## Mitsubishi hoist

No. 855-0229

## **Notice of Parts codes changes**

## 1. Object parts

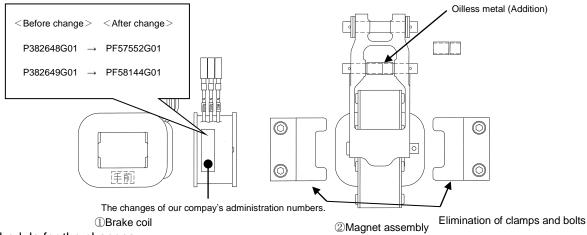
Part code			
Part name	Voltage	Before change	After change	Changes	
	200V Class	03G218	03G232	Administration number changes	
Brake coil	400V Class	03G231	03G233	200V Class : P382648G01→PF57552G01 400V Class : P382649G01→PF58144G01	
	200V Class	03H121	03H123	The coil figure number changes(Above)	
Magnet assembly	400V Class	03H122	03H124	The elimination of the clamps  The addition of the oilless metal assembly  (03H14V)

- 2. Schedule for the changes
  - ①Brake coil···production from Sep, 2010.
  - 2 Magnet assembly · · · production from Nov, 2010.
- 3. Reason of changes
  - (1) The partial change of the coil wire material.
  - (2) The improvement on customer satisfaction.
    - ①Since there are many requests for the addition of the oilless metal.
    - ②Since it is not necessary to replace the clamps in general.
- 4. Others
  - (1) The replacement guide of the oilless metal · · · Please replace the oilless metal if the oilless metal is worn out when the magnet assembly is replaced. Be careful when the oilless metal is pressed into magnet casing.
  - (2)The purchase of the clamps · · · Please order the clamps separately when they are necessary.
  - (3)The parts codes of Magnet assembly, Brake assembly and Brake·motor assembly are not changed.
